Our Ref: TSWC-L-0010-001
Your Ref: FRM/EC/1380/2024

RE: Land to the North of Exeter, Stoke Hill, Exeter
Outline Planning Application for up to 85 dwellings (35% affordable), community hub and associated infrastructure (All matters reserved except access)
(ECC Ref: 23/1380/OUT)

We refer to your statutory consultee response dated 28 February 2024 [REF: FRM/EC/1380/2024] in regard to the above application. We are pleased to see that the Lead Local Flood Authority (LLFA) has no in-principle objection to the proposals subject to the submission of additional information as outlined in your response as observations.

Figure 1: Screenshot of CEH FEH Web Service

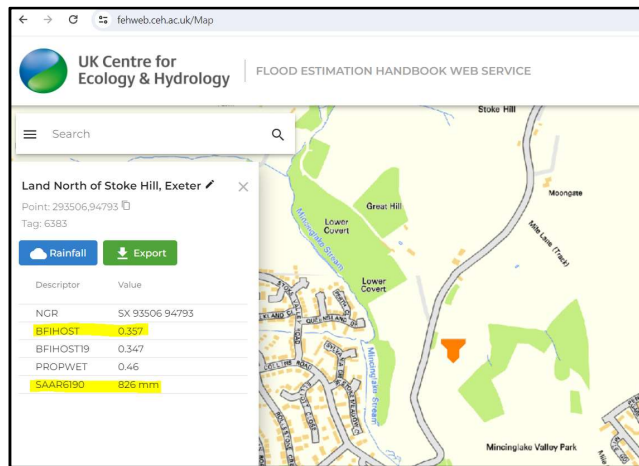
Observation 3: *"The greenfield runoff rates have been calculated using the FEH method. The applicant must submit a screenshot of the FEH web service to evidence the values used. The derived Q1 appears to be high at 5.52l/s/ha. The applicant shall check against the IH124 method." (verbatim)*

Response 3: As requested, a screenshot of the FEH web service evidencing the BFI and SAAR used in the calculations to determine Greenfield Runoff is presented below.
